New Telaire Product Upgrade Dust Sensor

Subject: Product Upgrade Notice of Dust Sensor

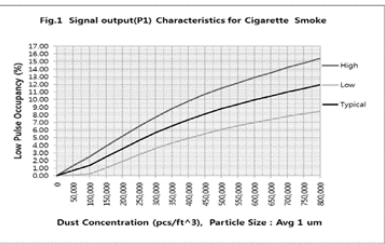
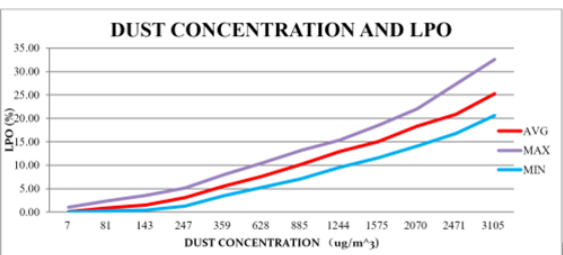
I am pleased to inform you that SM-PWM-01A dust sensor has been upgraded and the new part No. is SM-PWM-01C. The new part means only slight changes and improvements to the sensor and those are detailed on the attachment.

SM-PWM-01A dust sensor has been successfully upgraded and the new part No. is SM-PWM-01C. SM-PWM-01A had been all stopped production since Jan.1, 2016.

SM-PWM-01A	SM-PWM-01C
Appearance		
Output Characteristics		
Supply Voltage Ripple	< 100mV	<200mV, less disturbance when working with other components powered by the same source
Size (WxHxD) & Weight	59 x 46 x 18 mm 23g	59 x 46 x 18 mm 20g
Connector & Pins		No Change
